Subject: Recommendations Approval (2012) (AP-92) - Plains 8-Inch Moore To Jal #2 Release Site

RE: Annual Monitoring Report (2012) for the Plains Marketing's 8-Inch Moore To Jal #2 Release Site (AP-92)
Unit Letter J, Section 16, T17S, R37E, NMPM, Lea County, New Mexico Recommendations Approval

Subject: Groundwater Monitoring System Plan Amendment Approval (AP-92) - Plains 8-Inch

Subject: Plains Pipeline - Moore to Jal #2 site (AP-92)

Attachments: MJ#2 PMW map April 2013.pdf

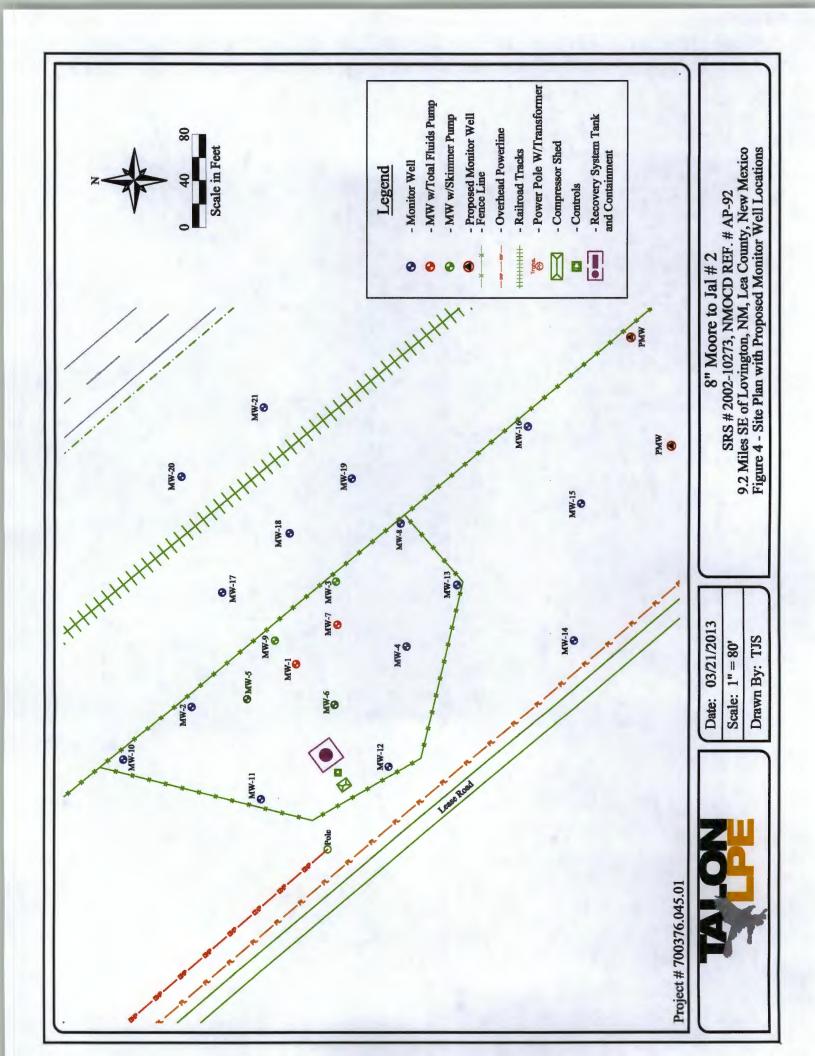
Plains Pipeline respectfully requests NMOCD approval to install 2 additional monitor wells at the above referenced site. Attached is a site map that depicts the approximate locations (PMW) where the 2 additional monitor wells will be installed.

The New Mexico Oil Conservation Division (OCD) has received the Groundwater Monitoring System Plan Amendment for the above-referenced site, dated April 12, 2013, and has conducted a review of the plan amendment. The plan amendment substantially meets the requirements of 19.15.30 NMAC. Therefore, the OCD hereby approves the plan amendment subject to the following conditions:

Plains must submit to the OCD an installation report for the two proposed groundwater monitoring wells within 90 days.
